STAFF RECOMMENDATION
1703 Ashwood Avenue
April 18, 2018

Application: New construction- addition
District: Belmont-Hillsboro Neighborhood Conservation Zoning Overlay
Council District: 18
Map and Parcel Number: 10416014100
Applicant: Will Jenner
Project Lead: Paul Hoffman; paul.hoffman@nashville.gov

Description of Project: The applicant proposes construction of a rear addition to this contributing building. The application also includes restoring the shingle siding on the second story and replacing the non-original porch columns.

Figure 2. Rear addition to be removed for new addition.

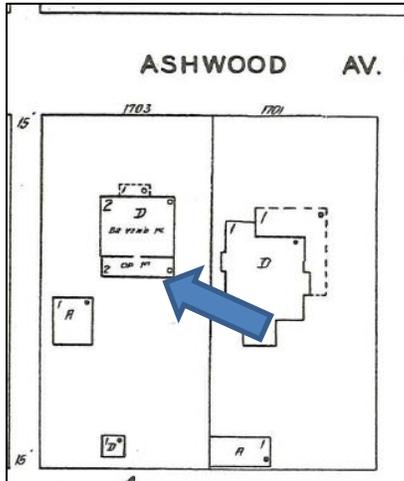
The application includes removal of an existing rear addition. This section was an open rear porch, enclosed at some point after 1957 (see Figure 3). As it is not original to the building, Staff finds that its removal is appropriate, and the application meets Section III.B.2 for appropriate demolition and does not meet Section III.B.1 for inappropriate demolition. See figures 2 and 3.

SITE PLAN

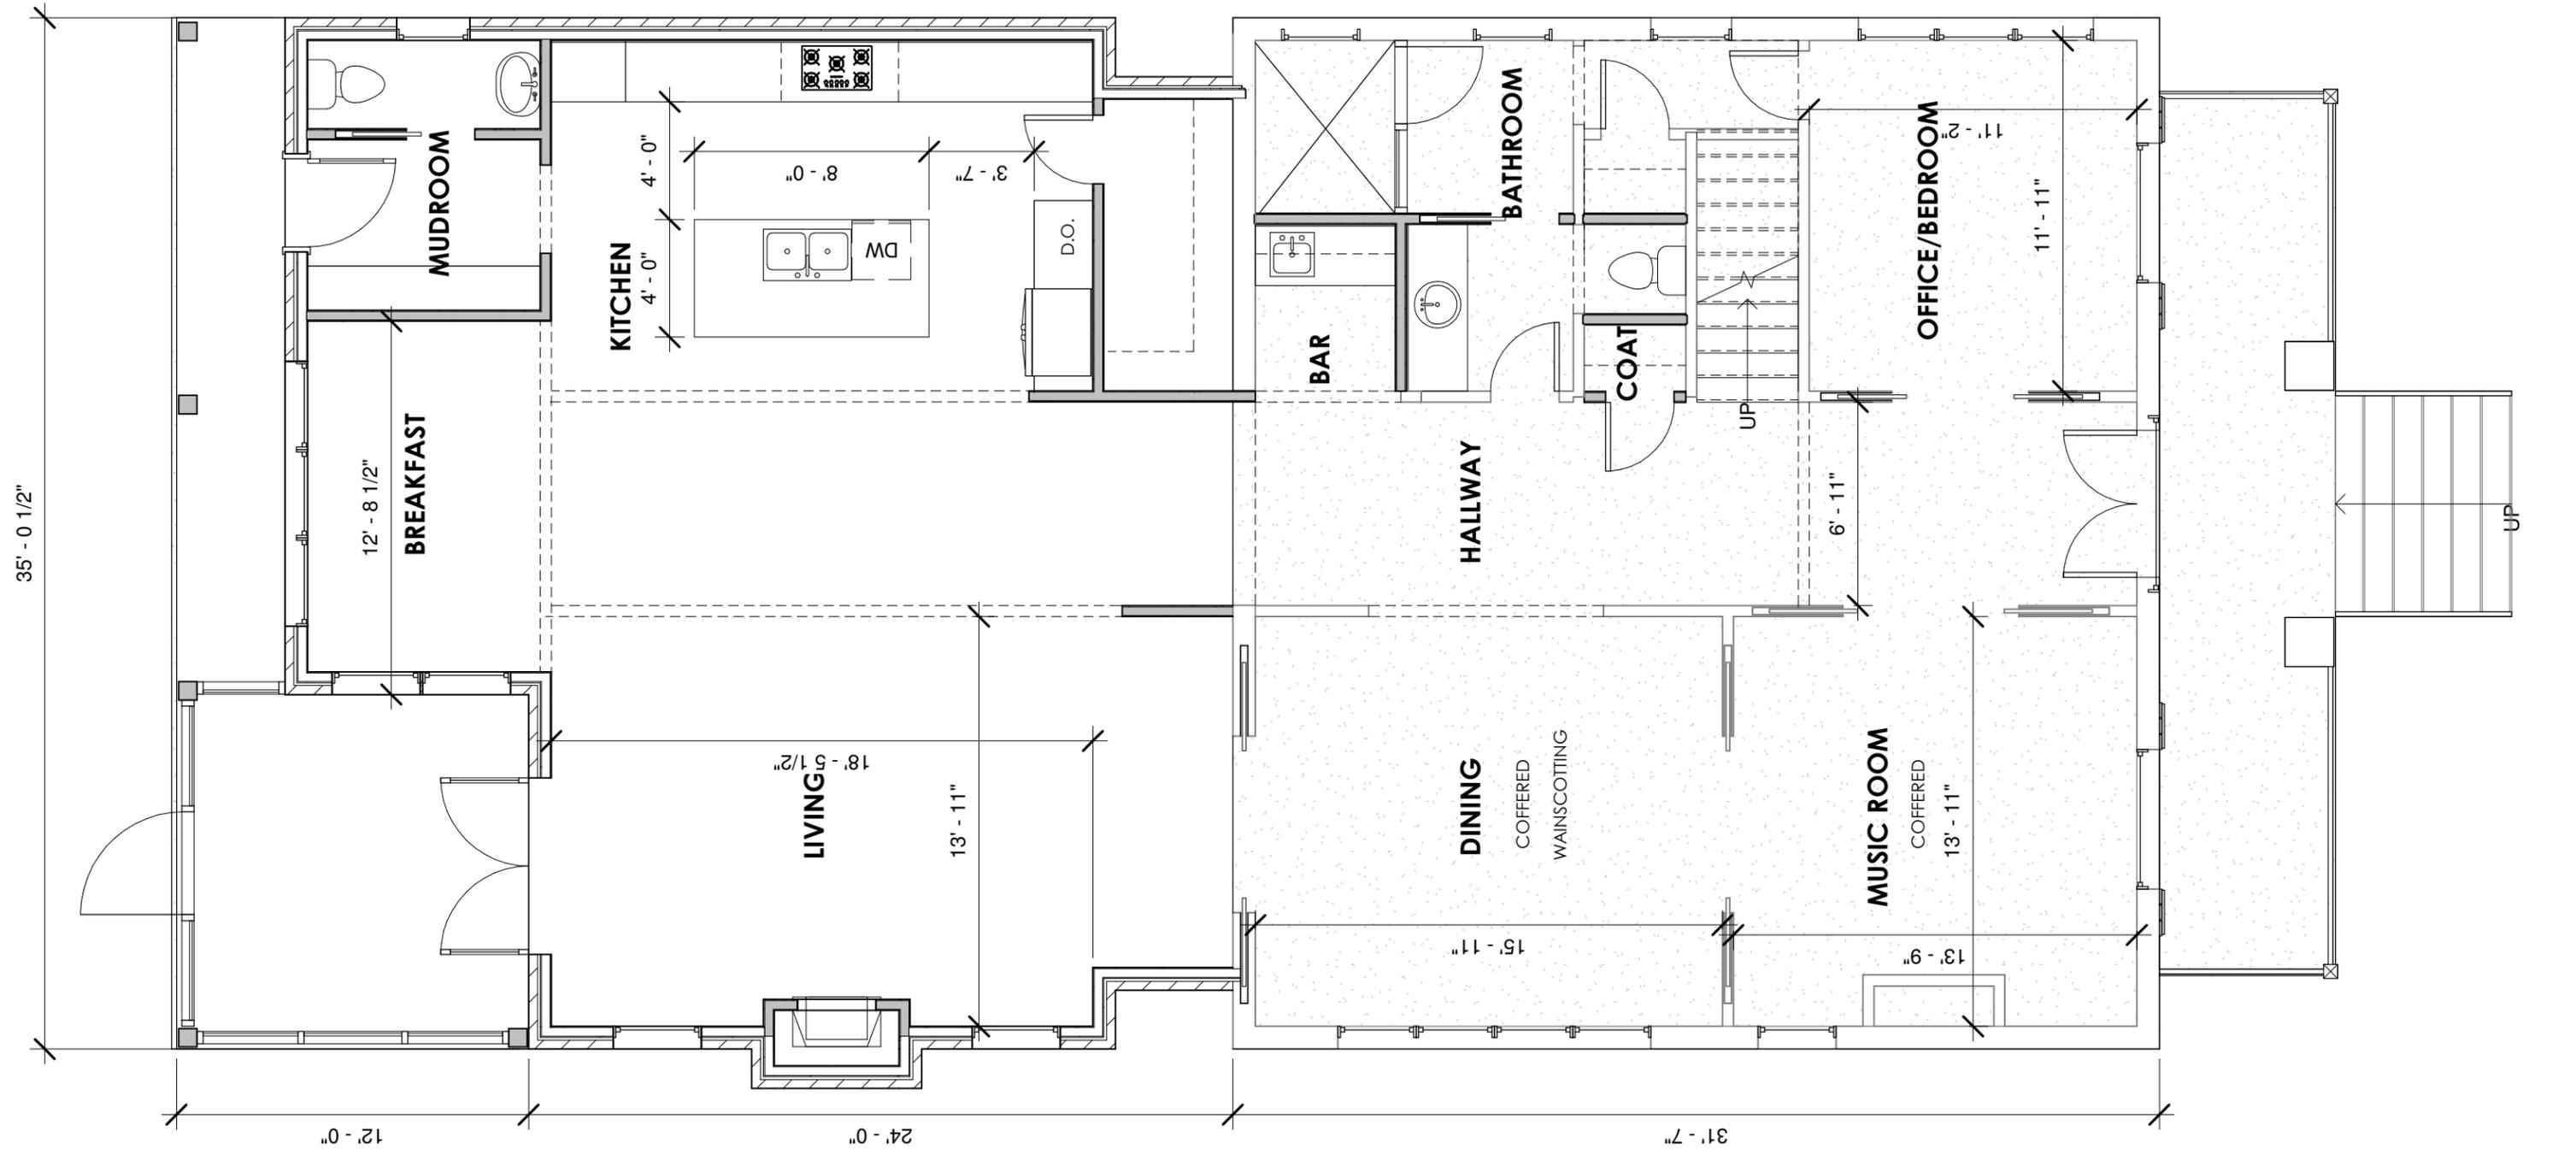
Setback & Rhythm of Spacing: The addition will be nineteen feet (19') and twenty-one feet (21') from the right and left sides respectively, and will be approximately sixty-one feet (61') from the rear property line. The addition meets base setback requirements of five feet (5') on the sides and twenty feet (20') at the rear. The project meets section II.B.1.c.

Outbuildings: The site plan includes an outbuilding which may be proposed in the future. Drawings have not been received, and it is not part of this application.

Outbuilding is not part of this application
